DEPARTMENT OF THE NAVY		NAVAL FACILITIES ENGINEERING SYSTEMS COMMAND		APPROVED	
NAVAL FACILITIES ENGINEERING SYSTEMS COMMAND ~ MID-ATLANTIC		NAVAL SHIPYARD - PORTSMOUTH, NH		FOR COMMANDER NAVFAC	
PUBLIC WORKS DEPARTMENT - MAINE		KITTERY, MAINE		ACTIVITY	
PORTSMOUTH NAVAL SHIPYARD		CONTRACT NUMBER: TBD		SATISFACTORY TO DATE	
		P-1112 B72 RESILIENCY IMPROVEMENTS		DESIGNER MTC	
		OPTION 13: ACCESSORY STRUCTURE		DRAWN BY	
				CHECKED BY MEC	
				DESIGN MANAGER JTL	
				PROJECT MANAGER LBT	
				DESIGN DIRECTOR MMR	
				FIRE PROTECTION SSR	
SHEET 29 OF 226		C-108 FAC-YR-NUM

EPROJECT NO.:		1710371	
NAVFAC DRAWING NO.			
SHEET		60	OF 226
A-402		FAC-YR-NUM

H ENLARGED PLAN - ACCESSORY STRUCTURE
SCALE: 3/8" = 1'-0"

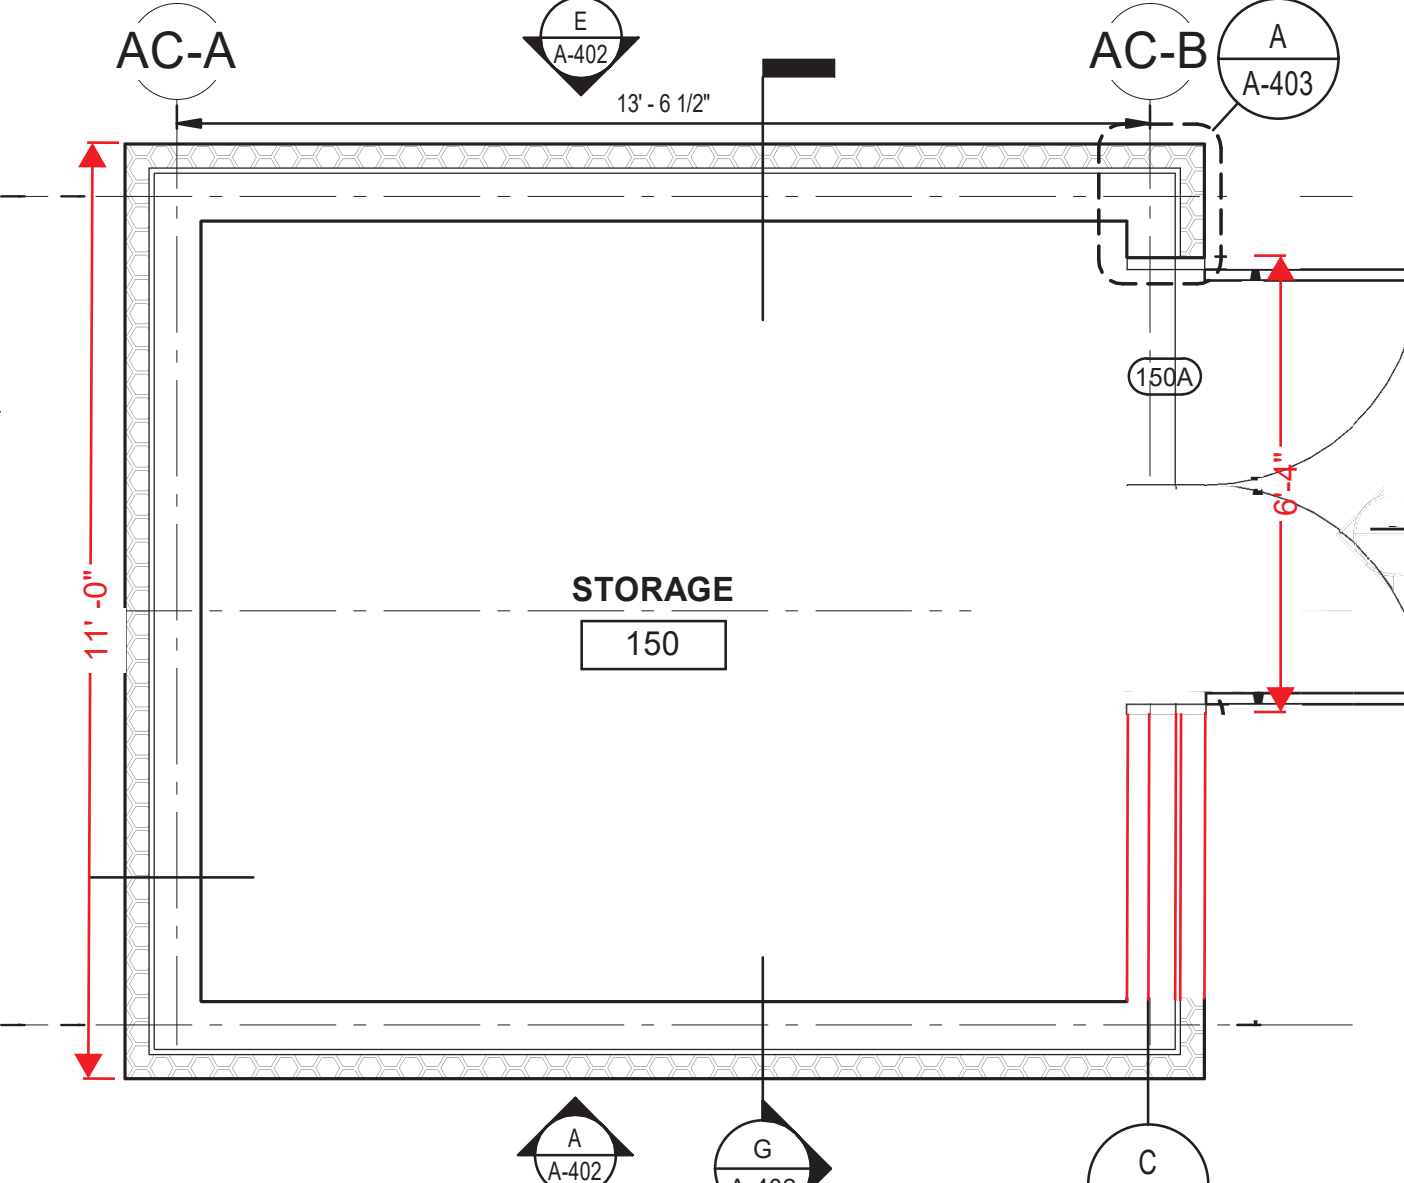
13. BID OPTION # 13: **NEW STORAGE BUILDING:** PRICE TO INSTALL NEW STORAGE BUILDING IN ACCORDANCE WITH THE DRAWINGS AND SPECIFICATIONS
